# Access Compliance Report

## Public Rights-of-Way

### (Curb Ramps)

| Intersection ID: 10028229 | Main Street: HEATHSTEAD_PL | Cross Street: N/A       | Location: NW           |

| ADA ID: D512DD98FCCE      | Ramp Type: PerpDiag        | Initial Pass/Fail: Fail | Overall Compliance: No |

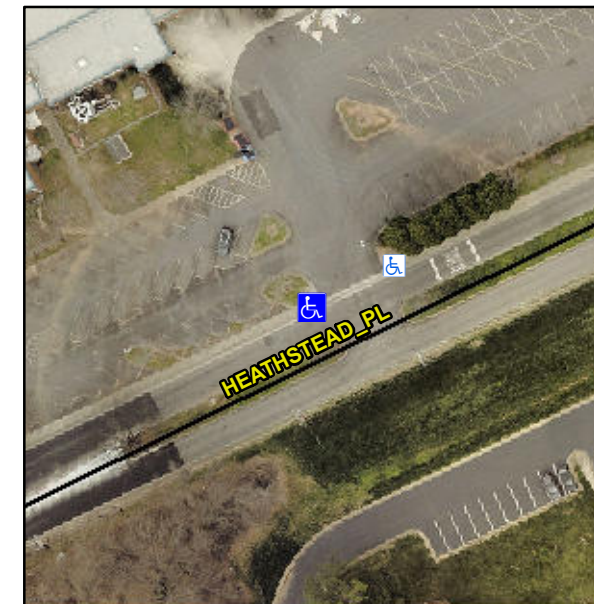
**Remove & Replace Curb Ramp With Two New Directional Ramps or Equivalent.**

**Not Found, R304.5.3**

| Compliance | Description           | Data  | Compliance | Description                 | Data  |
|------------|-----------------------|-------|------------|-----------------------------|-------|
| Yes        | Ramp Width (in)       | 48.0  | No         | Ramp XSlope (%)             | 7.1   |
